APPENDIX A

A2. Correspondence

- i. 1st Submission Comments***
- ii. Meeting Minutes***
- iii. Hydrologic Modelling***
- iv. Buffers and Allowances***

**DRAFT PLAN OF SUBDIVISION
ORLANDO CORPORATION**

File : G:\Projects\2017117197 - Orlando - North Porta3 - Drawings\6. SWM\FSR FIGURES\FIG 5-1 - Development Constraints Map.dwg, Layout : 5-1c Date: Feb 10, 2022 - 4:43pm, Edit By : Iony.dang

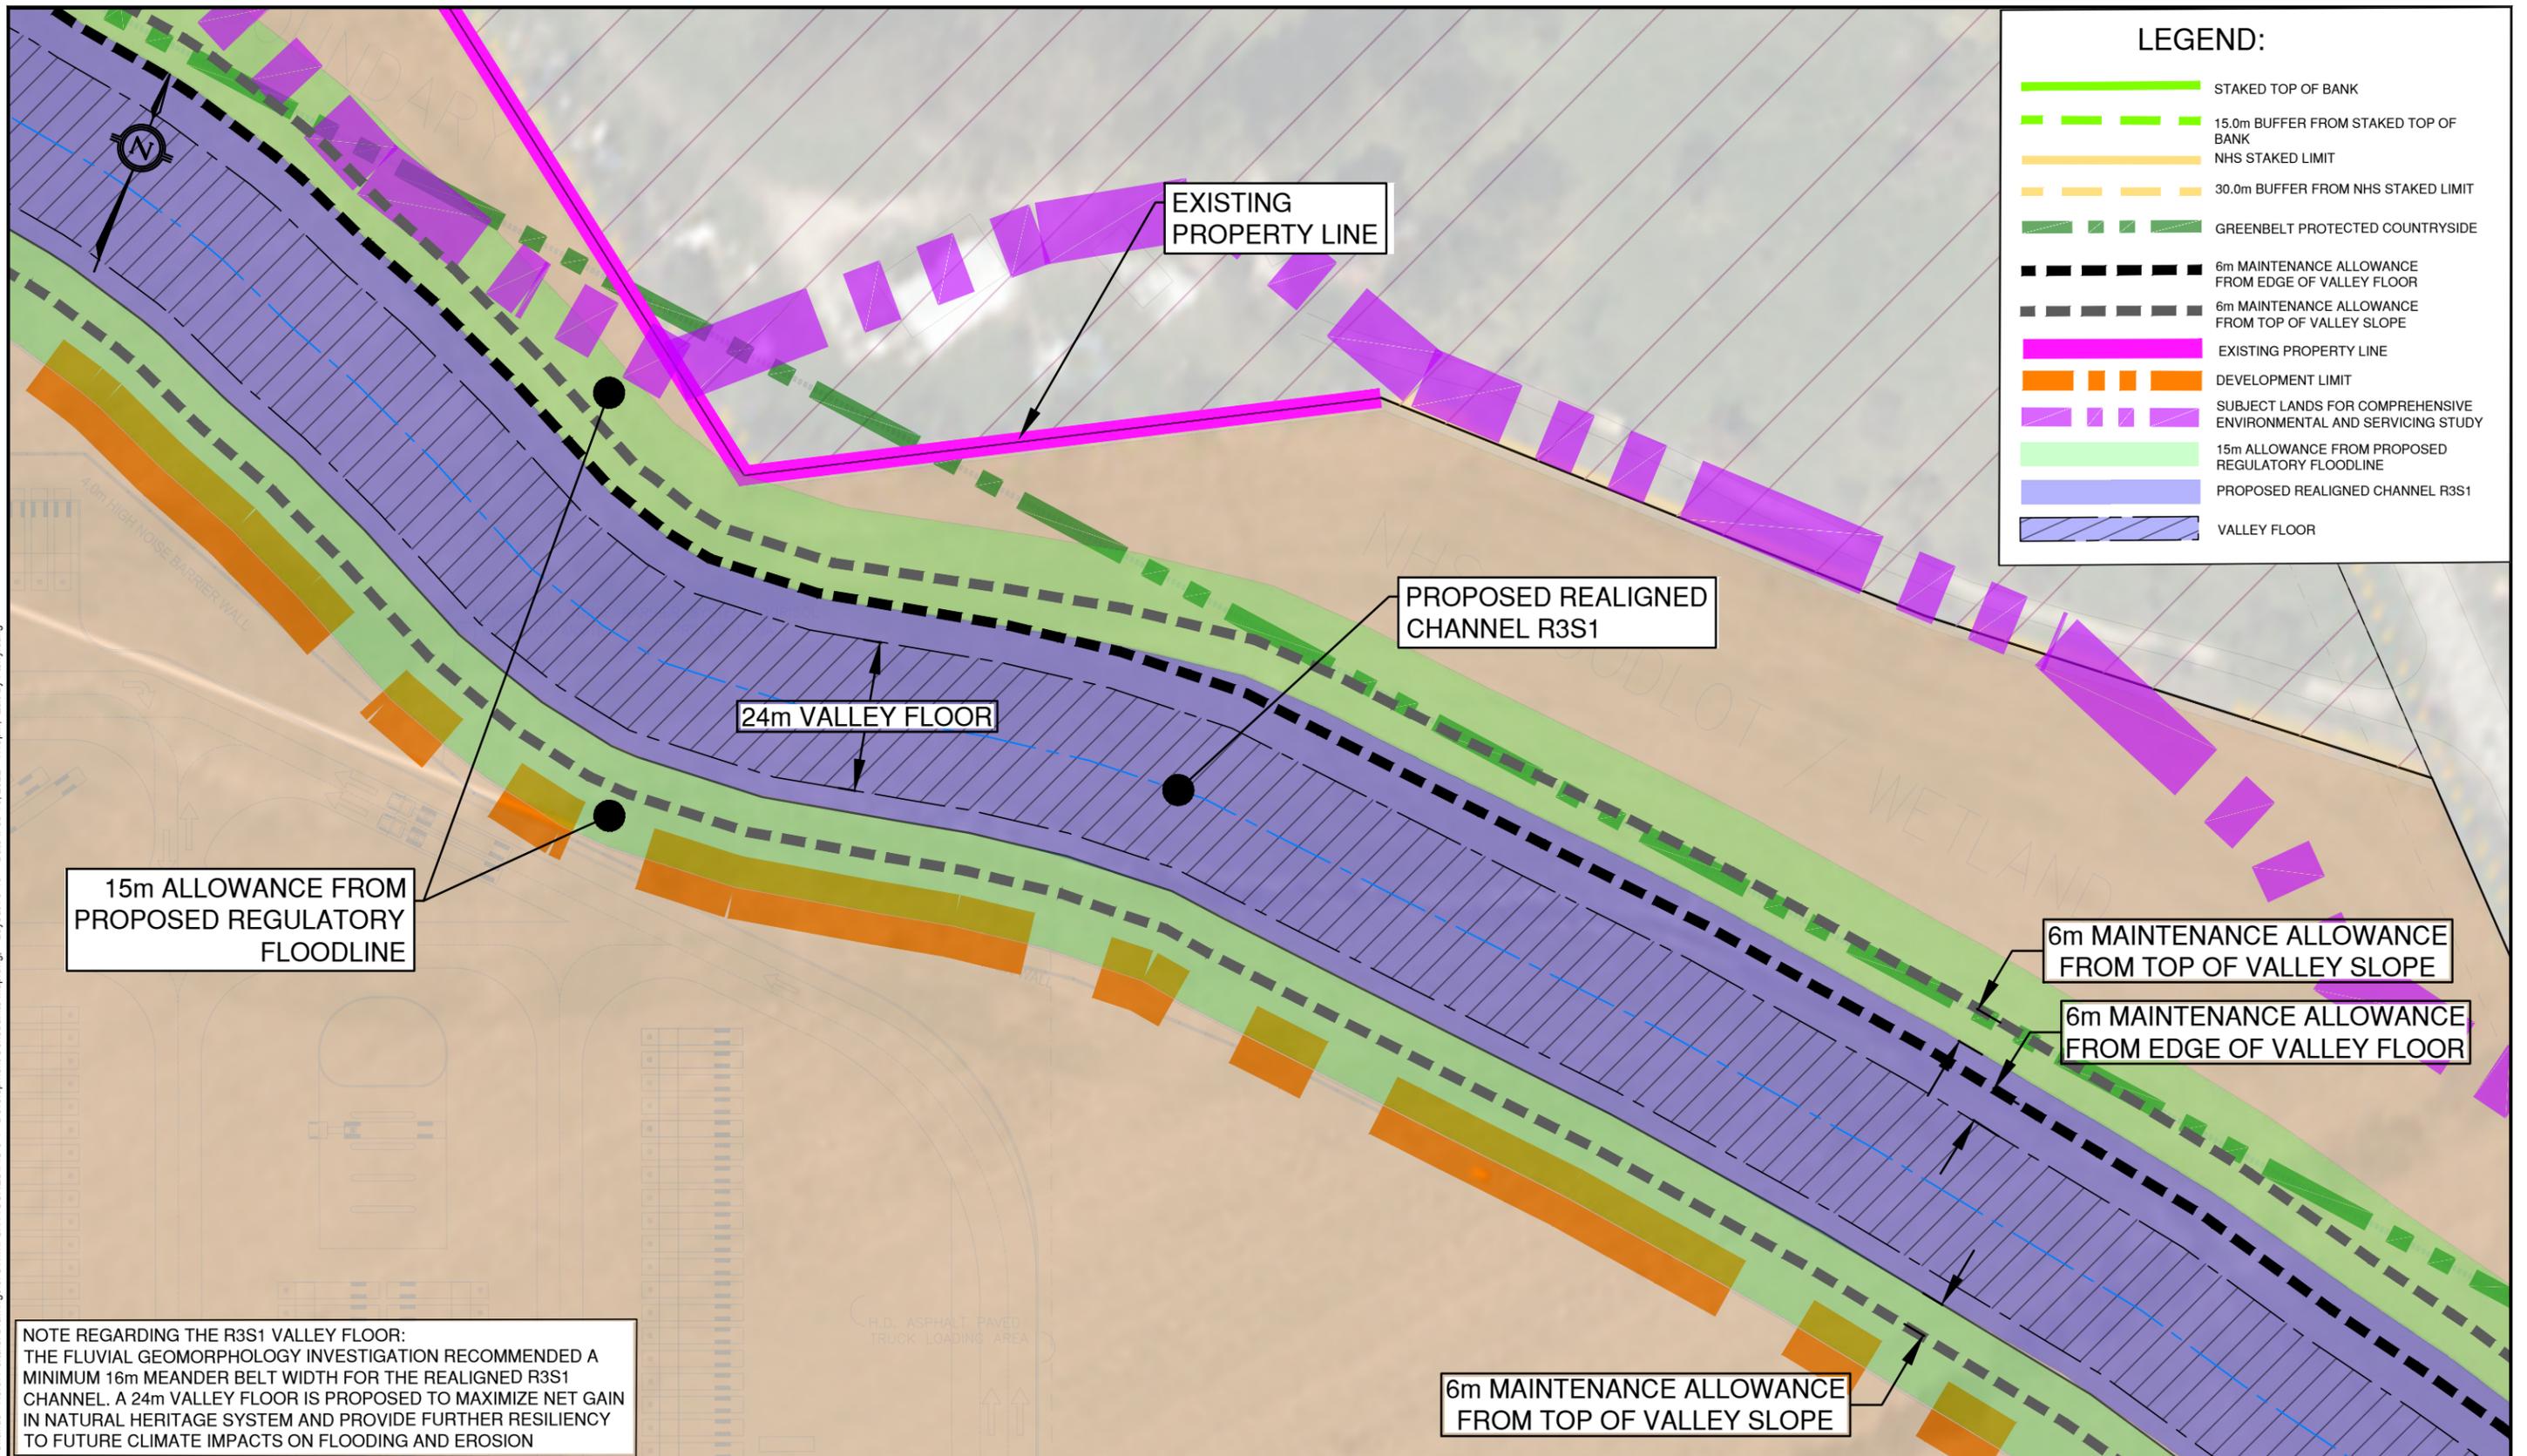
- xiii) Section 6.1.10 – There is discussion on both a 15 m regulatory setback from the proposed floodline, and from the top of bank (on the development side of the channel). It is unclear in Figure 5-1 that there is a setback from the top of the design valley, rather it states from the floodline. If the design corridor conveys the Regional Storm flood up to the top of bank, then the limit would be the same. The text is somewhat unclear when reviewed in the context of Figure 5-1.
